**Subject:** ASTP 210312.01 | Change to App and Response to IR for TPC-77 at 1133-1139

Our ref: 210312.01 Council Ref: TPC-77

Re: Change to the Application and Response to Council's Information Request

Other Change to Town Planning Consent Permit TPC 77 for modifications to existing Deer Farm,

Figure 1 Approved Site Plan

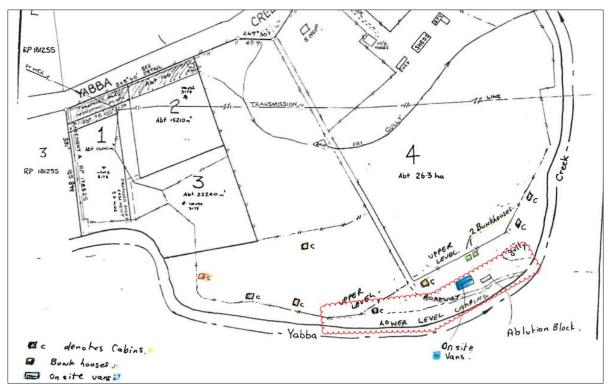
No consideration or assessment has been made against the Temporary Local Planning Instrument- Protection of Biodiversity Values (TLPI). Of particular concern is the impact of the introduction of events producing 86- 90dB(A) (and additional lighting and vibration which has not been assessed) within Core Ecological Linkage and Priority Species Habitat overlay and near the waterway.

Modify the overall development layout such that the newly proposed 'event' areas are in an area that minimises the impact on the environmental values mapped under the TLPI. Alternatively, provide an assessment against the TLPI, ensuring to consider the following:

The existing campsites down by the creek remain, as roughly shown on the approved plan included as **Figure 1** below. This is shown on the revised Proposal Plans in **Attachment 1**.

Encl: Revised Proposal Plans prepared by Ace Space Design (Attachment 1)

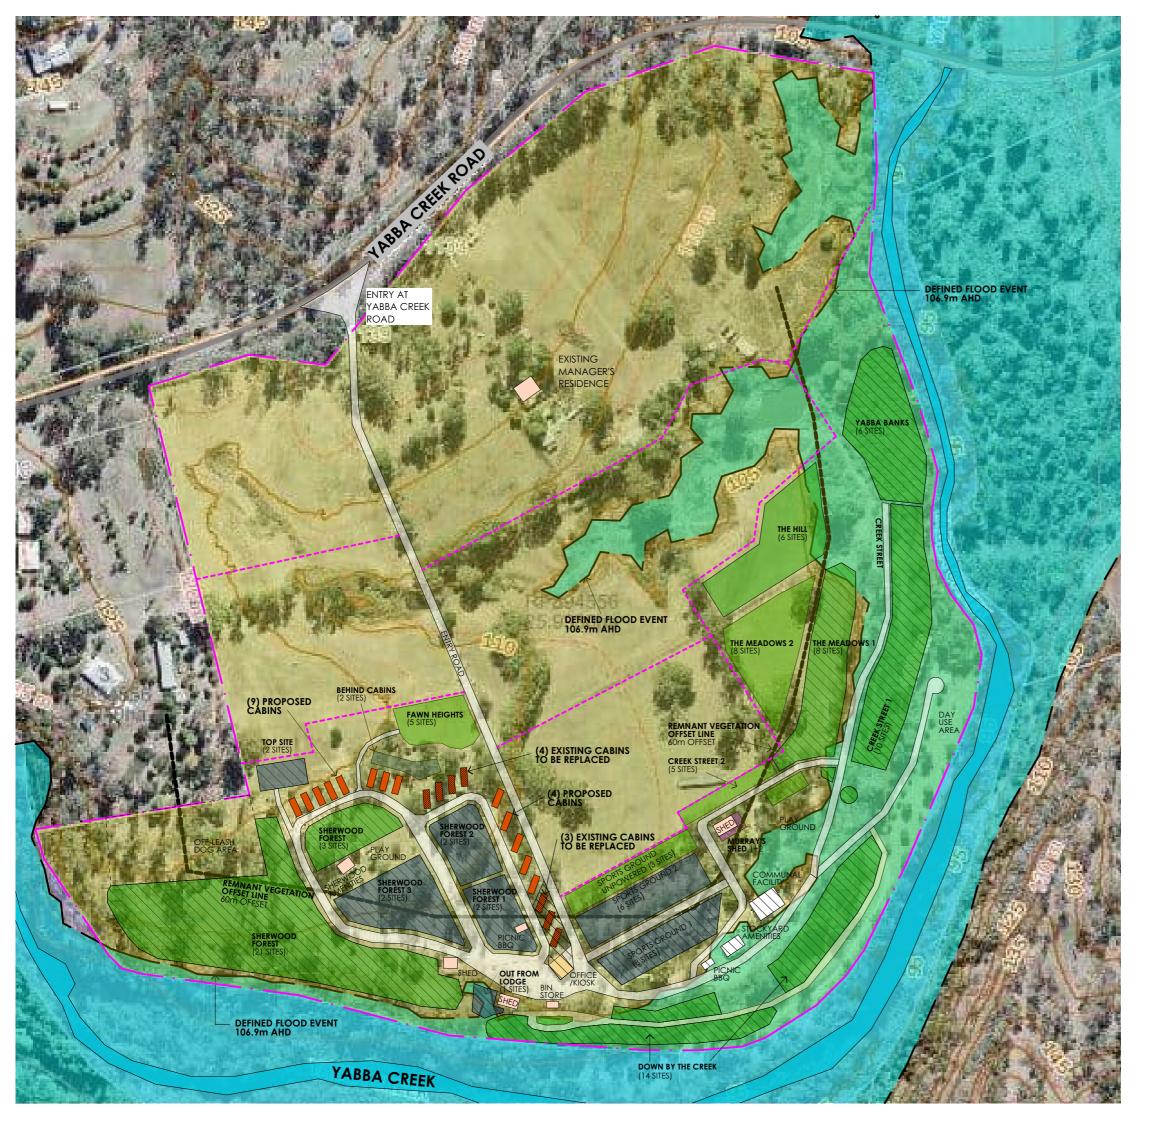
- 1. Provide further evidence to substantiate the claim that the current approval permits 2000 people to be located onsite or that the sites were undefined/unlimited by size.
- 2. Provide a detailed site plan, showing the area for the existing approval for all tent/trailer sites, caravan, bunk houses, cabins and permanent caravan sites and additionally provide a site plan for the proposed 75 tent/trailer sites, caravan sites and 12 cabins. On the plan, include a legend to indicated numbers in each grouping ie. Tent/campers/cabins etc.
- 3. Advise the maximum number of people allowed or that can fit per site.

Proposal plans for the new use areas following conventional plan making standards has not been supplied (i.e., scale, north point, use area dimensions etc).

Submit updated proposal plans addressing the above concerns.

As detailed above, the revised Proposal Plans in **Attachment 1** nominate the approved sites (hatched) versus the proposed sites to be added to the approval, with an accommodation schedule included to detail the number of people able to be accommodated in each camping area/site. In total, a 28 site net increase is proposed (105 sites approved, 133 sites proposed) across the cabin and tent/trailer sites to remain/be delivered, with all other forms of accommodation having been removed. Each tent/trailer site will accommodate a maximum of twelve (12) people in three (3) tents as per Council's advice, but the land size of the sites varies based on location, given the nature and scale of the premises.

Please refer to the revised Proposal Plans prepared by Ace Space Design in Attachment 1.
